Determination 2010/78

Refusal to issue a code compliance certificate for a house with tiled decks at 42E Rarangi Road, St Heliers, Auckland

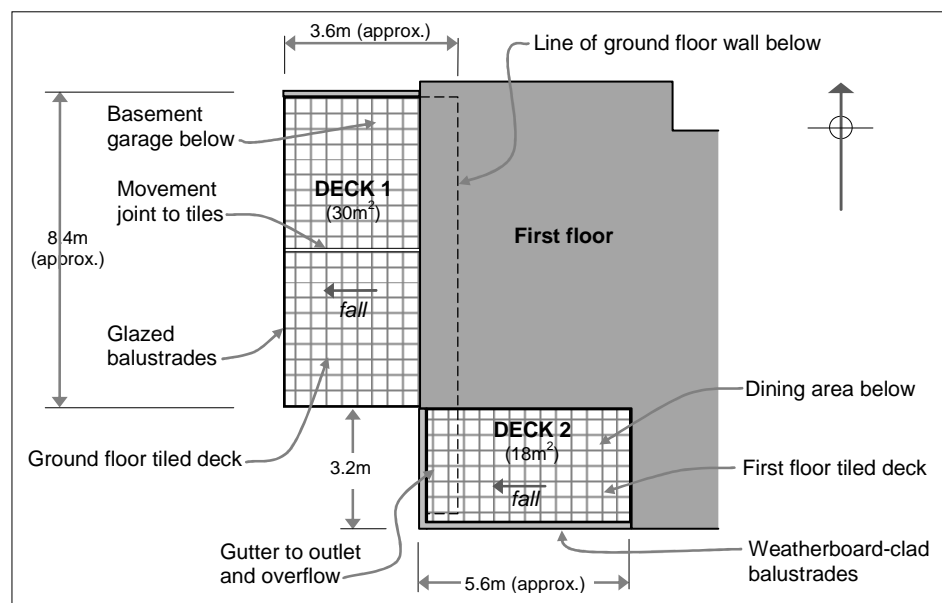
- 2.2.1 The house has two enclosed decks as shown in the following sketch:

- 2.2.2 “Deck 1” is a 30m² ground floor deck situated above the western end of the basement garage. The deck includes an aluminium louver screen to the north and a louver canopy to the north end. The balustrades are glazed, with stainless steel posts side-fixed to the deck edge and a gap under the bottom rail. A movement joint is installed

- 2.2.3 “Deck 2” is an 18m² deck on the southwest corner of the first floor; and is situated above the ground floor dining room. This deck has framed balustrades clad in fibre-cement weatherboards to both sides. The deck floor falls to the western end – into a tiled gutter draining to an outlet and overflow at the southeast corner.
- 2.2.4 Both decks have tiled floors, with the tiles adhered to a membrane applied over a plywood substrate. The specification calls for the deck framing to be ‘H3’ and the plywood substrate to be 18mm ‘H3 type treatment’.

- 5.2.3 Following the hearing, the attendees visited the house to view the decks. It was observed that Deck 1 (the larger deck) incorporated a movement joint within the tiled surface. There had been rain prior to the visit and I was able to observe the effect of rainwater falling onto the deck tiles and also to note a loose tile on Deck 2, where no movement joint had been incorporated into the tiled surface.

7.4 However, taking account of the authority's submission at the hearing, observations of the deck tiles following the hearing and further information from the adhesive supplier, I conclude that the following areas require attention:

- The lack of a central movement joint to the tiles of Deck 2.
- The loose tile to Deck 2. A check to be made of the adhesion of that tile and any damage that may have occurred to the membrane underneath it
- Investigation of the tiles to both decks, to confirm that tiles are fully adhered.

- 9.1 In accordance with section 188 of the Building Act 2004, I hereby determine that the deck membrane systems installed on the building do not comply with Clause B2 of the Building Code, and accordingly
- I confirm the authority's decision to refuse to issue a code compliance certificate, and
 - the authority is to modify the notice to fix, dated 1 March 2010, to take account of the findings of this determination.
